**Application No.: PL9056**

Description :	
Address :	
Record Type :	PLAT

# GENEVA HEIGHTS, BLOCK 2, LOT 1A

BEING A RE-PLAT OF LOTS 1, 2 AND PORTION OF LOT 6, BLOCK 2, GENEVA HEIGHTS, A SUBDIVISION OF THE CITY OF CORPUS CHRISTI, NUECES COUNTY, TEXAS, ACCORDING TO THE MAP RECORDED IN VOLUME 8, PAGE 51, MAP RECORDS OF NUECES COUNTY, TEXAS.

UTILITY MAP

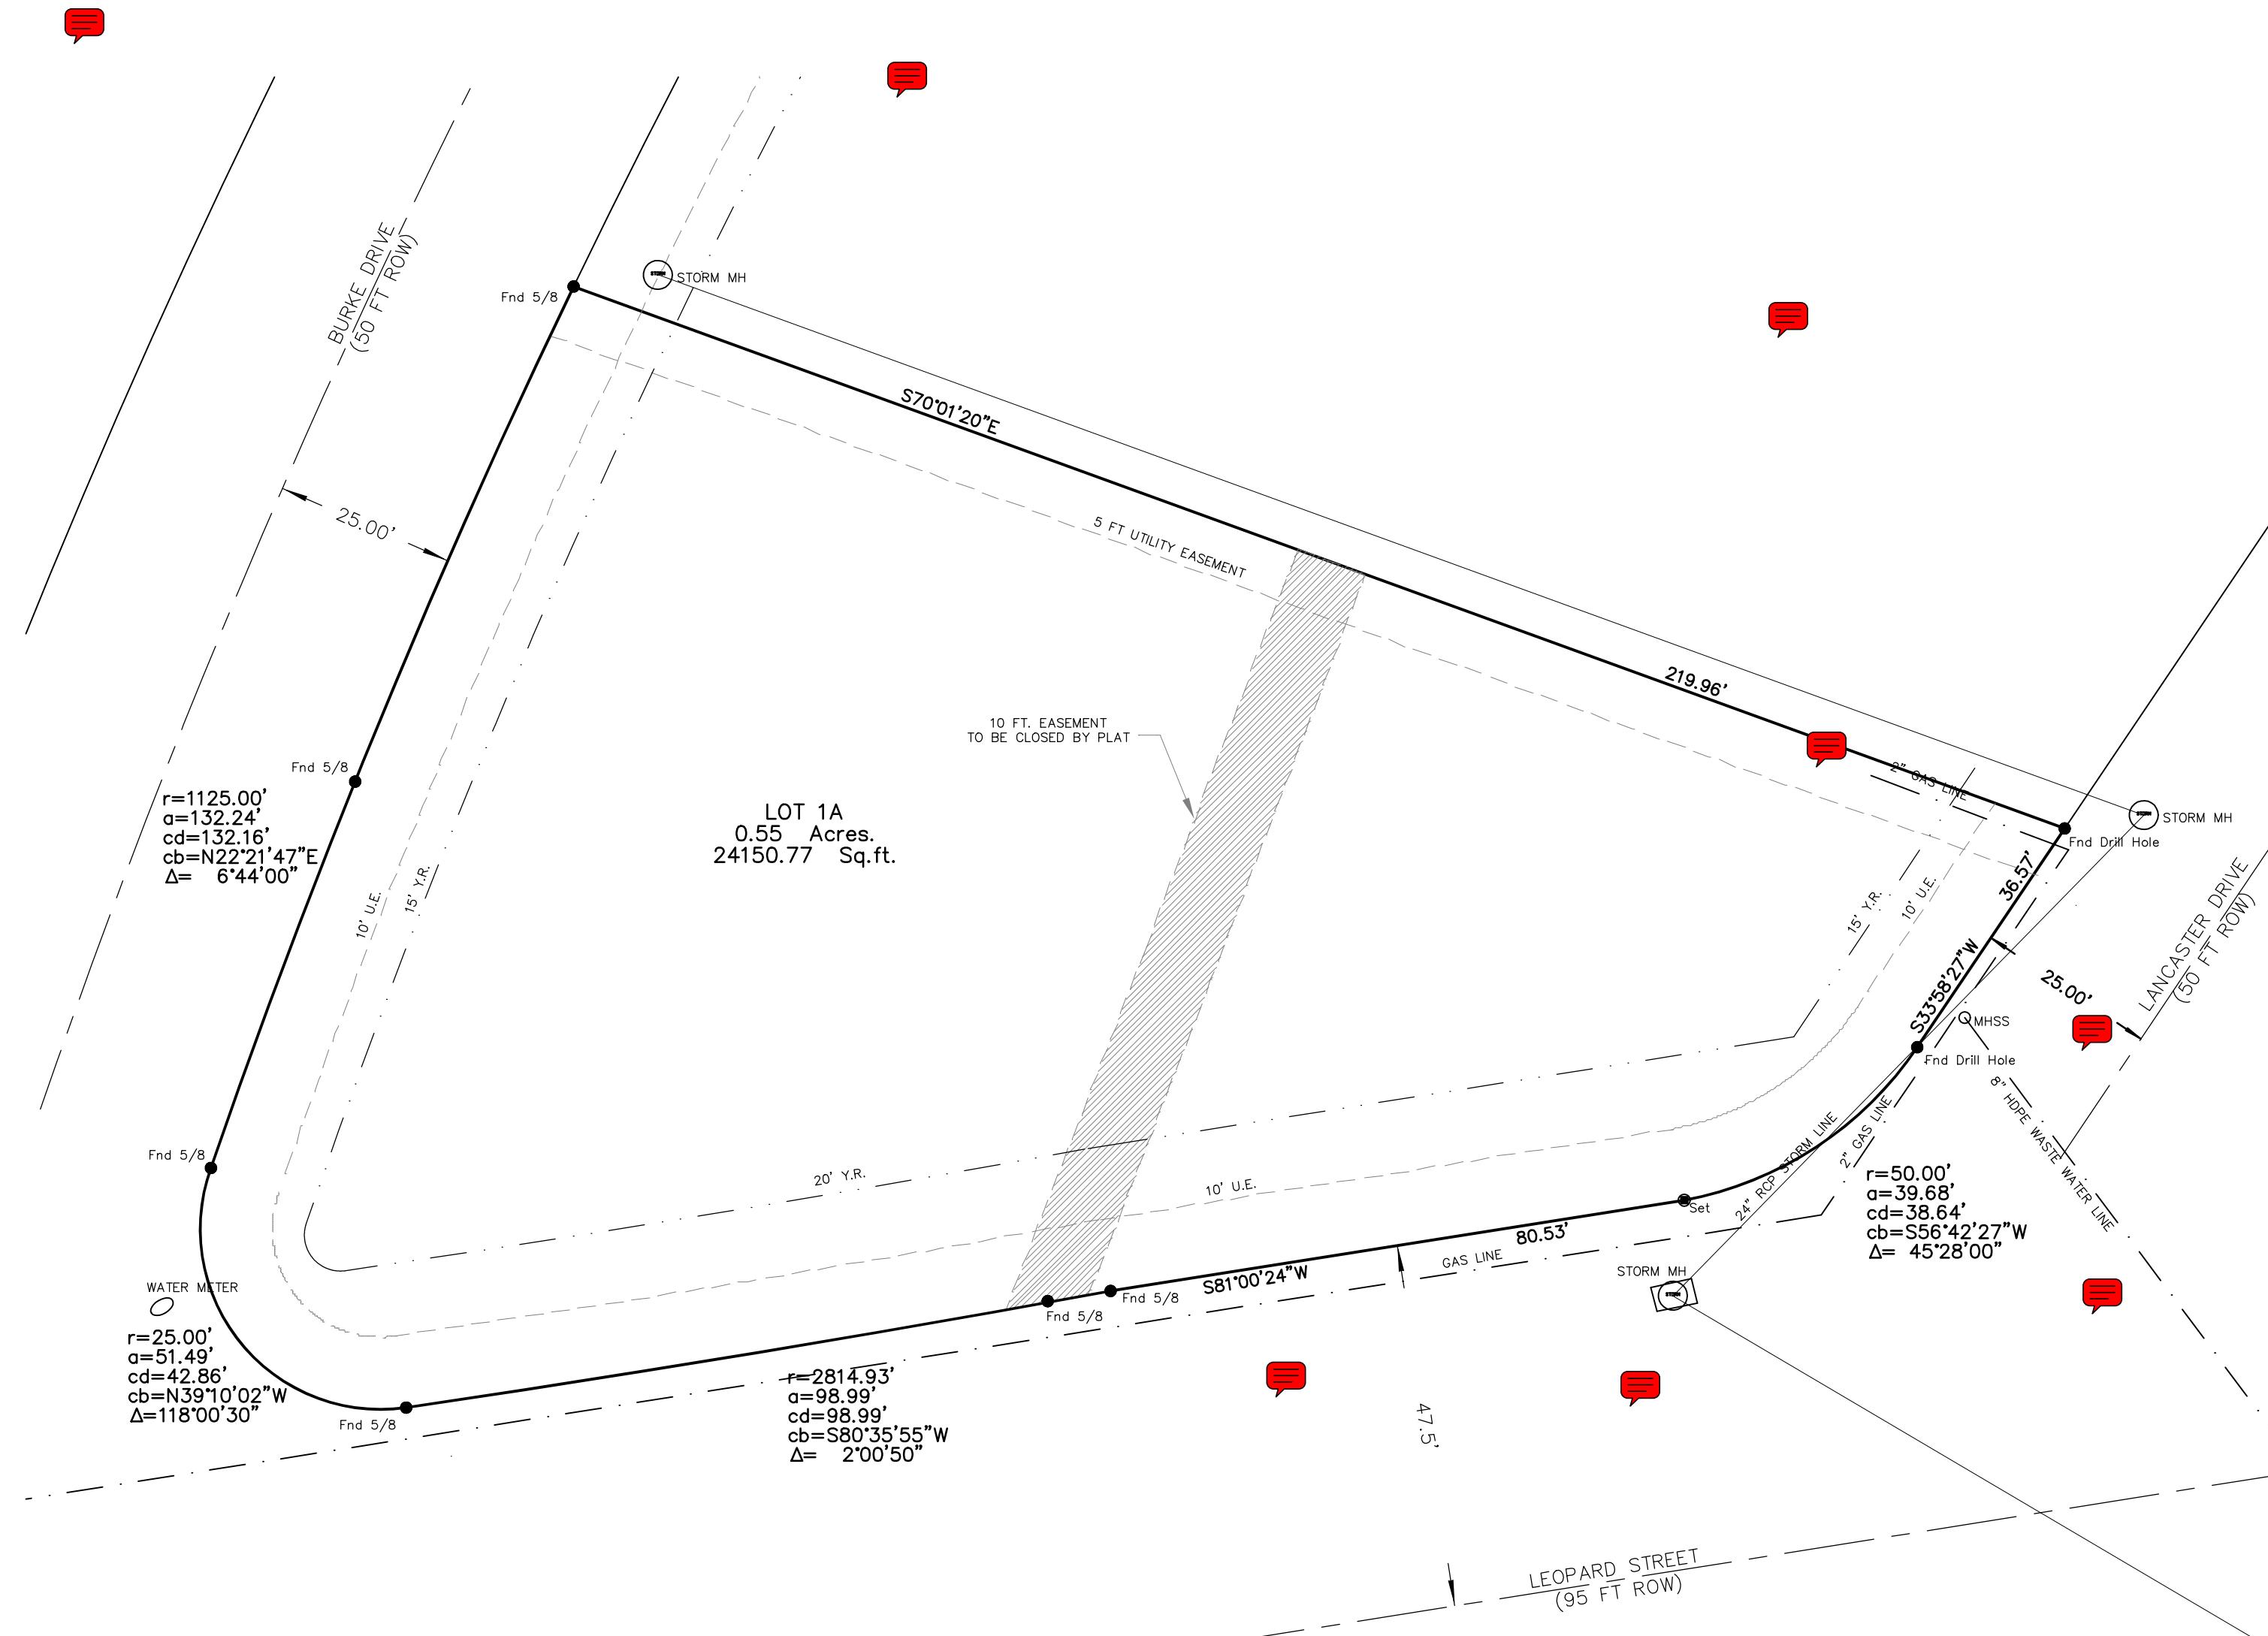
28	P001	Note	Mina Trinidad : DS	Closed	15-foot corner yard requirement per CN-1 Neighborhood Commercial District standards.	
29	P001	Note	Mina Trinidad : DS	Closed	Increase site location map text and zoom more into subject property.	
5	U001	Note	Alex Harmon : DS	Closed	Verify alignment of 2" gas line. City records show it on subject lot not neighboring lot.	
6	U001	Note	Alex Harmon : DS	Closed	Show location of water meter that was found during site survey to verify no water construction is required.	
7	U001	Note	Alex Harmon : DS	Closed	Show stormwater line along Lancaster and Leopard	
11	U001	Note	Mina Trinidad : DS	Closed	CCW: (Edgar Diaz Ruiz)  12/15/25 Update: 1. Water construction is not required for platting (UDC 1.2.1.D & 8.2.6; Water Distribution Standards). 2. Wastewater construction is not required for platting (UDC 1.2.1.D & 8.2.7; Wastewater Collection System Standards).  Please see below CCW's comments: 1. Water construction is required for platting (UDC 1.2.1.D & 8.2.6; Water Distribution Standards). 2. Wastewater construction is not required for platting (UDC 1.2.1.D & 8.2.7; Wastewater Collection System Standards).

17	U001	Note	Mina Trinidad : DS	Closed	Fire:

Comment ID	Page Reference	Annotation Type	Author : Department	Status	Review Comments	Applicant Response Comments
					<p>(Captain Mark Lewis)</p> <p>1. Note: All code reference is based on currently adopted International Fire Code (IFC) 2021 and Corpus Christi Water Distribution Standards.</p> <p>2. Commercial Development shall have a fire flow of 1,500 GPM with 20 psi residual Fire hydrant every 300 feet and operational. A fire hydrant will likely be needed.</p> <p>3. 507.5.1 (amendment) Where Required: All premises, other than one-family detached dwellings, where buildings or portions of buildings are located more than 150 feet from a fire hydrant shall be provided with approved on-site hydrants and water mains capable of supplying the fire flow require by the fire official. The minimum arrangement being so as to have a hydrant available for distribution of hose to any portion of building on the premises at distances not exceeding 300 feet.</p>

18	U001	Note	Mina Trinidad : DS	Closed	<p>(Informational) Fire:</p> <p>(Captain Mark Lewis) Comments 4-12</p> <p>4. 507.5.4 Obstruction. Unobstructed access to fire hydrants shall be maintained at all times. The fire department shall not be deterred or hindered from gaining immediate access to fire protection equipment or fire hydrants. Note: Hose lay from a hydrant will not cross an arterial street. In this instance, the fire hydrant across the street at Leopard and Up River is unavailable for our use.</p> <p>5. 912.2.3 (amendment) Proximity to Hydrant: Fire department connections (FDC) for each sprinkler system or standpipe system shall be located not more than 100 feet from the nearest fire hydrant connected to an approved water source</p> <p>6. 3310.1 Required access. Approved vehicle access for firefighting shall be provided to all construction or demolition sites. Vehicle access shall be provided to within 100 feet of temporary or permanent fire department connections. Vehicle access shall be provided by either temporary or permanent roads, capable of supporting vehicle loading under all weather conditions. Vehicle access shall be maintained until permanent fire apparatus access roads are available.</p> <p>7. D102.1 Access and loading. Facilities, buildings, or portions of buildings hereafter constructed shall be accessible to fire department apparatus by way of an approved fire apparatus access road with an asphalt, concrete or other approved driving surface capable of supporting the imposed load of fire</p>

Comment ID	Page Reference	Annotation Type	Author : Department	Status	Review Comments	Applicant Response Comments
					<p>apparatus weighing at least 75,000 pounds.</p> <p>8. 503.1.1 (amendment) Buildings and facilities: During construction, when combustibles are brought on to the site in such quantities as deemed hazardous by the fire official, access roads and a suitable temporary supply of water acceptable the fire department shall be provided and maintained.</p> <p>9. Note: An accessible road and a suitable water supply is required once construction materials are brought on site.</p> <p>10. 503.2.1 Dimensions. Fire apparatus access roads shall have an unobstructed width of not less than 20 feet, exclusive of shoulders and an unobstructed vertical clearance of not less than 13 feet 6 inches.</p> <p>11. D103.1 Access road width with a hydrant. Where a fire hydrant is located on a fire apparatus access road, the minimum road width shall be 26 feet, exclusive of shoulders</p> <p>12. 503.4 Obstruction of fire apparatus access roads. Fire apparatus access roads shall not be obstructed in any manner, including the parking of vehicles. The minimum widths and clearances established in sections D103 shall always be maintained.</p>

19	U001	Note	Mina Trinidad : DS	Closed	<p>(Informational) Fire: (Captain Mark Lewis) Comments 13-16</p> <p>13. 503.3 Marking: Where required by the fire code official, approved signs, or other approved notices the include the words NO PARKING-FIRE LANE shall be provided for fire apparatus access roads to identify such roads to prohibit the obstruction thereof. The designation of a fire lane can be marked with conspicuous signs which have the words: "Fire Lane-No Parking" at 50-foot intervals. In lieu of signs, fire lanes may be marked along curbing with the wording, "Fire Lane-No Parking" at 15-foot intervals.</p> <p>14. 503.2.5 Dead ends. Dead-end fire apparatus access roads more than 150 feet in length shall be provided with an approved area for turning around fire apparatus.</p> <p>15. Per Fire Code. Conveyor style pizza ovens are required to have built in suppression systems unless the cooking equipment meets the standards of UL710B.</p> <p>16. Commercial development of the property will require further Development Services review.</p>
